Re: EPA approval of UniFirst's draft VI Scope of Work submitted March 25, 2010

EPA, in consultation with MassDEP, has reviewed your revised "Indoor Air Quality and Vapor Intrusion Assessment Scope of Work Revision 2" (SOW) and "Quality Assurance Project Plan Revision 1" (QAPP) submitted on March 25, 2010, for the UniFirst Source Area Property (15 Olympia Avenue, Woburn, MA). EPA approves of the SOW and QAPP, with the following conditions:

PRE-SAMPLING BUILDING INSPECTION
FEBRUARY 15, 2010
UNIFIRST CORPORATION
WOBURN, MASSACHUSETTS

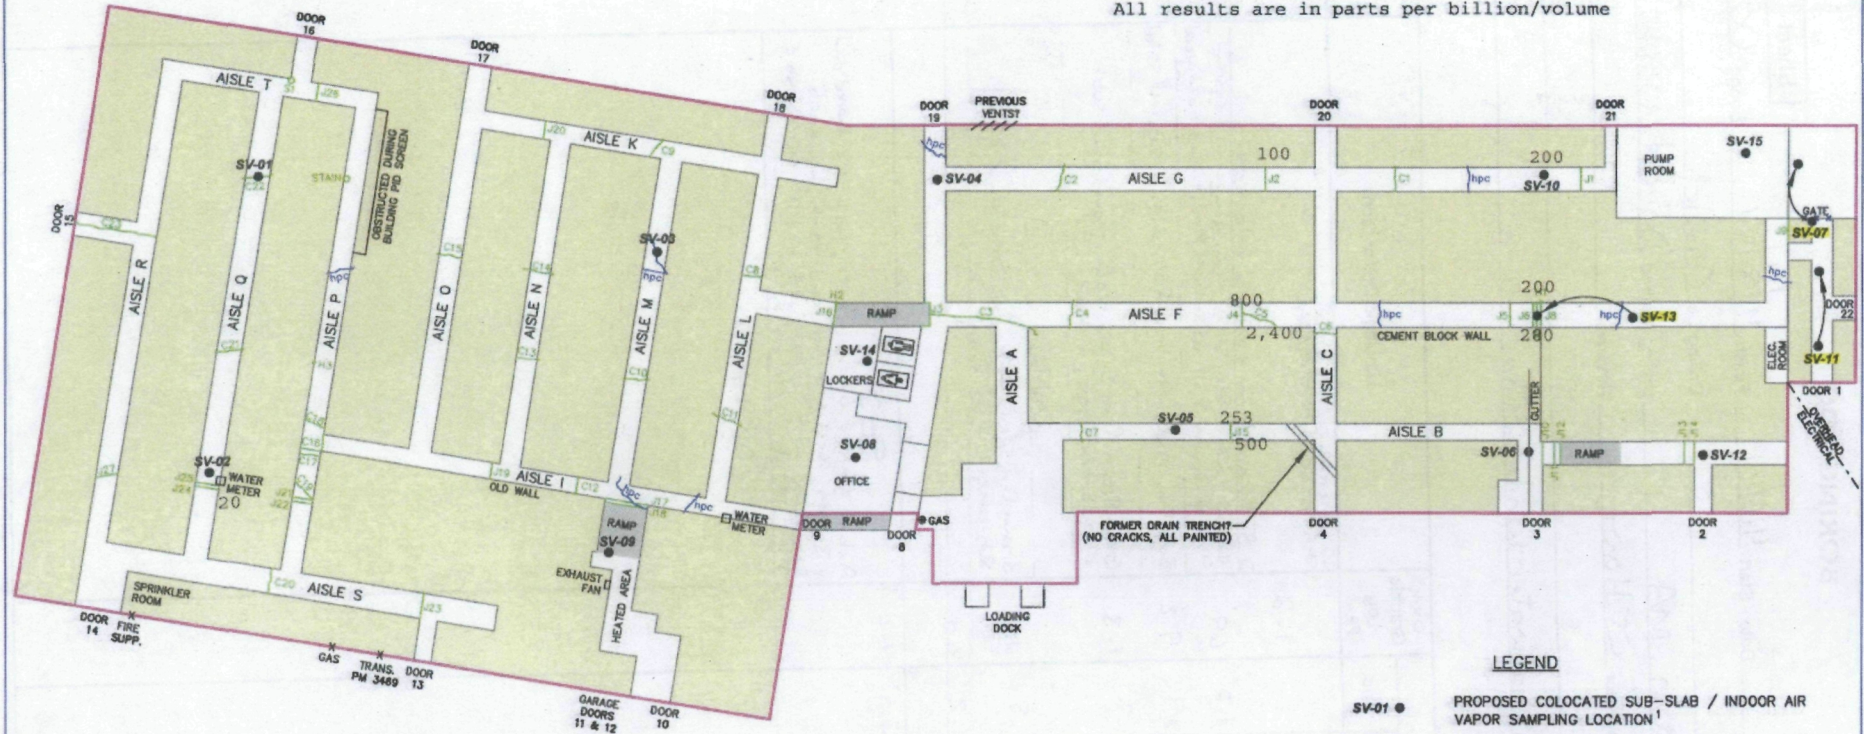
- During the March 15, 2010 inspection, technical representatives from both EPA and UniFirst utilized and recorded readings from photo-ionization detection (PID) equipment. Please see the attached figure illustrating the maximum recorded PID readings during the March 15th inspection. As illustrated on the figure, some elevated readings (40-50 ppb) were recorded in the back room of the office. These readings may be associated with some of the office materials and/or cleaning products stored in the back room. Consistent with the page 11 of the SOW, please have these materials/products/chemicals removed prior to sample collection so they do not potentially interfere with the work, as well as removing any other materials/products/chemicals within the building that may interfere with the work.
